High Lifter Crossover Tubes

Part # 1405 New Style Crossover Tube, 1999 to present

Top View of Right Head

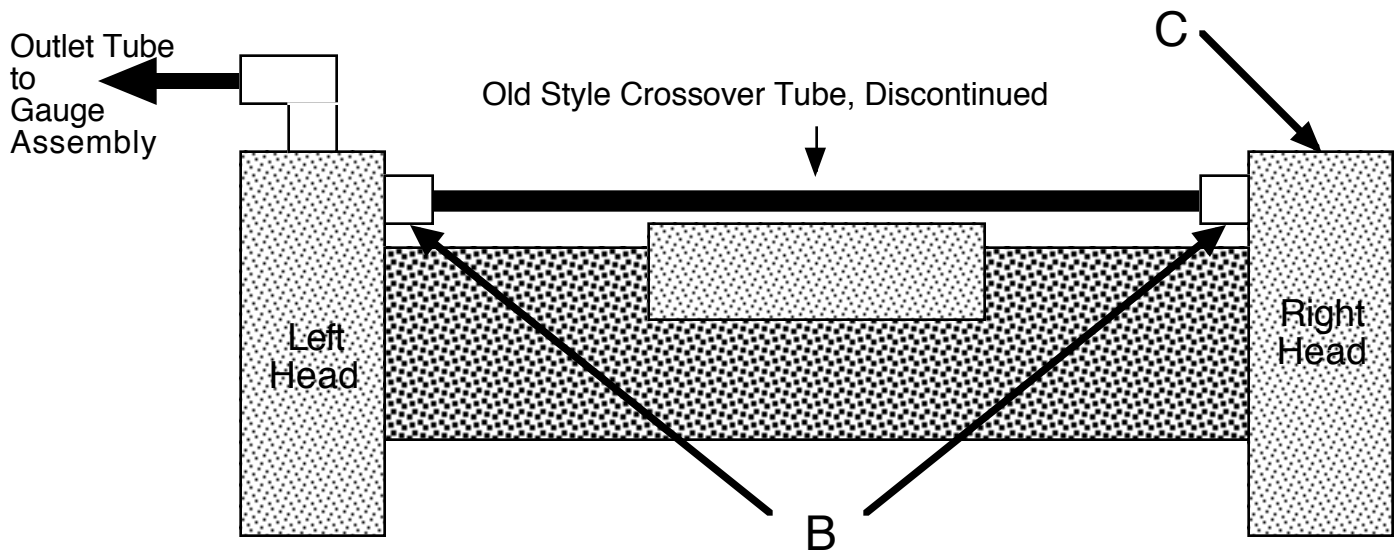
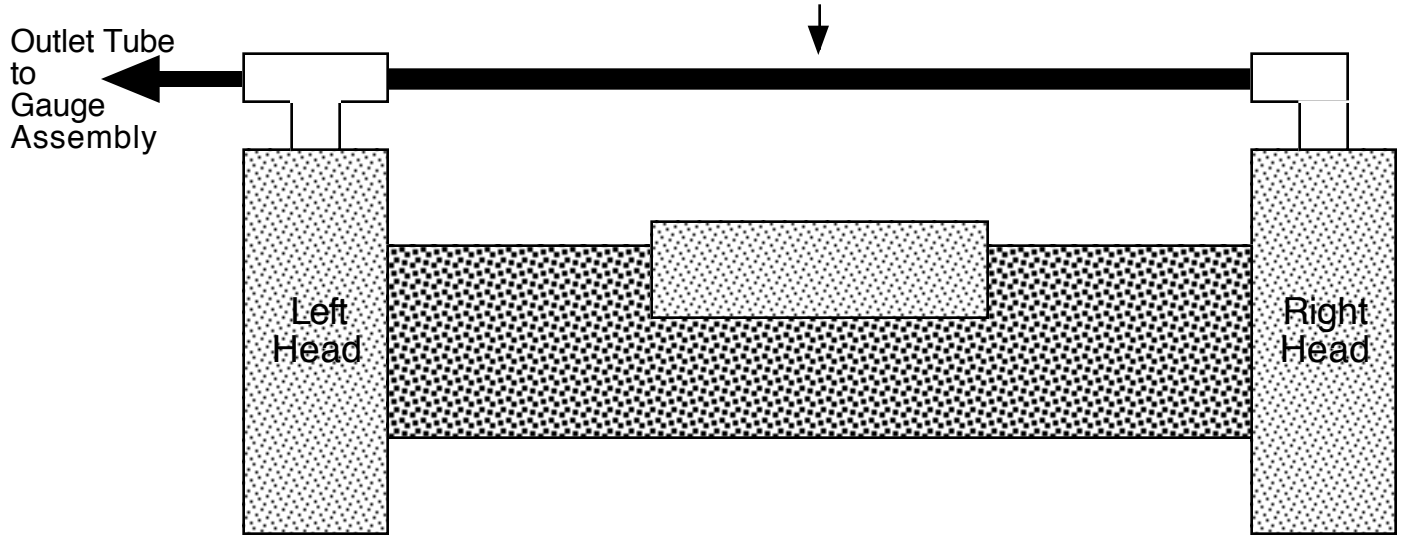
- 1) Remove old style crossover tube
- 2) Remove fittings at both "B" locations.
- 3) Install a #1387 1/4 Slotted Plug, at each "B" location.
- 4) Remove old plug from CENTER hole at "C".
- 5) Install #1407 EII Fitting at center hole of "C".
- 6) Remove EII Fitting from Left Head.
- 7) Install #1410 Tee Fitting in Left Head.
- 8) Install #1405 Crossover Tube
- 8) Be sure to use Teflon tape to seal all threads.

Remove this
plug and
replace with
EII Fitting
